Cr Nicole Johnston

22 February 2017

I am writing to make a submission to the draft Yeerongpilly Transit Oriented Development (TOD) Detailed Plan of Design and State Planning Regulatory Provision 2016 (SPRP) dated December 2016.

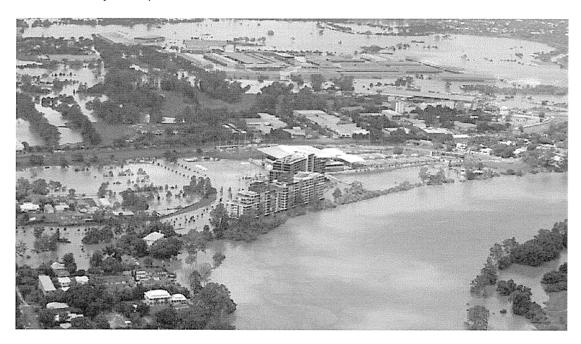
There have been 11 major floods recorded on this site over the past 170 years the most recent in January 2011, pictured.

The picture below clearly demonstrates the extent of flooding on the site. Only a very small part of the site did not flood. This area is bounded by the heritage buildings, Fairfield Road and the Tennyson Spur Line.

The January 2011 flood was significantly lower than the 1974 flood. While each flood is different, on more than 11 occasions over the past century plus this site has flooded. This area is a geographic low point on the Southside and will flood again in the future.
